# Product Change Notification

Date Issued :	December 19, 2025	PCN Number :	517686
Reason for Change :	Capacity change or tool replacement		
Description of Change :	<p>Series 42385 has seen an increased demand (4 and 6 CKT configurations).            The project aims to tool up a new, high-capacity mold capable of providing an additional 1.8M pc/month to ensure full supply.</p>		
Reason for Short Notice :	Capacity Increase		
Assessment of Change :	Dimension analysis		
Planned Implementation Date :	May 14, 2026		
Customer Sample Availability Date:	February 13, 2026		
Last date to request Samples by Customer :	February 16, 2026		
Please note if Samples are not requested as per Customer Samples Request date, it may take additional 4-6 weeks to arrange Samples.			
Traceability Code Markings / Date :	Cavity identification

Before Picture

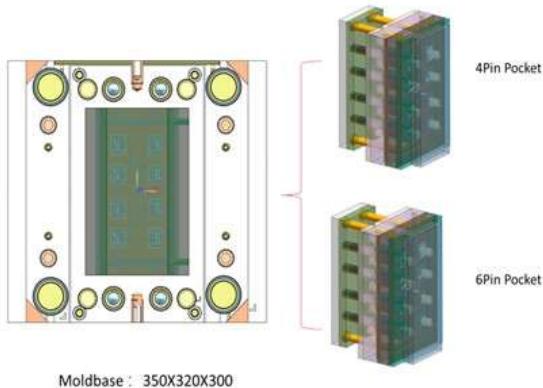
The new mold design and process optimization ensure multiple operational opportunities:

1. Material opportunity: Improvement runner design decrease from 10.5 g to 4 g (estimate).
2. Setup time opportunity: Setup time from 4hr to 1hr.
3. Efficiency and Maintenance: Improve POEE from 82% to 95%.

## Mold design concept

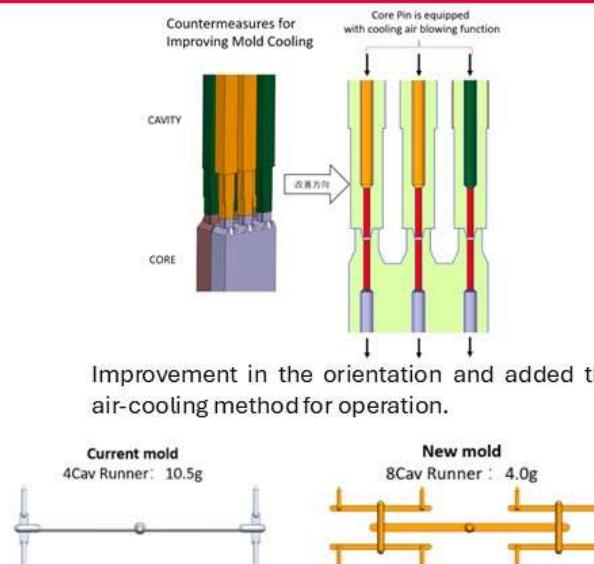
The switching between 4-pin and 6-pin is achieved by quickly changing the mold core block.

With the new runner design we can reduce the runner weight around a 6.5gr
